# Expert Notification

## On Estimating GHG Emissions and Primary Energy of Vehicles Tested in Green NCAP - LCA Methodology and Data

Dr. Gerfried Jungmeier, JOANNEUM RESEARCH – Institute for Climate, Energy and Society (LIFE)

Graz, May 12 2022

**Figure 1:** Climate change related impacts, based on current literature (Crenna et al. 2021)

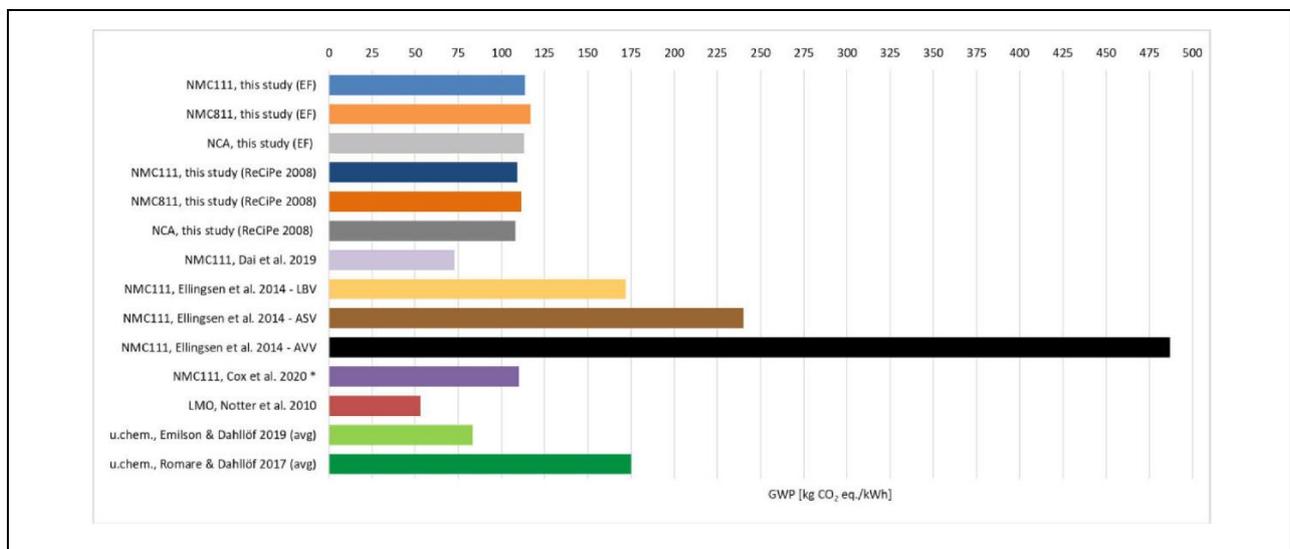
*Are Green NCAP and Joanneum overestimating battery production? Modern studies are known to claim battery production greenhouse gas emissions (GHG) of 50 -75 kg CO<sub>2</sub>-eq./kWh, while Joanneum has used a value of 120 kg CO<sub>2</sub>-eq./kWh.*

The LCA of automotive batteries system and its components were modelled with the JOANNEUM RESEARCH in-house “JR Battery LCA-Tool”, based on available international literature (see e.g.

The LCA of battery systems was conducted for various locations of battery production (Europe, US and China). Based on the current locations of battery production, a global average weighted for battery production was used to calculate the GHG emissions and the primary energy demand (e.g. China 75%).

The calculated GHG emissions for battery production were also compared to other studies, which show comparable results, but also differences due to specific parameters e.g. energy density, material composition, chemistry, energy source and components included. In the LCA also recycling and reuse of batteries were considered summing up to GHG emissions of 99 kg CO<sub>2</sub>-eq/kWh. (see Table 2 and Figure 1, where the mentioned GHG emissions of 50 – 75 kg CO<sub>2</sub>-eq/kWh are quite on the lower range but are possible in Europe e.g. in new giga factories using a high share of renewable energy but still raw materials from global supply chains). Using new data for batteries in UK with a share of battery production in EU of 43% (Asia 30%, US: 14%, RoW: 13%) the average estimated GHG emissions of battery are 82 g CO<sub>2</sub>-eq/kWh.

Remark: Notter et al, 2010 is outdated
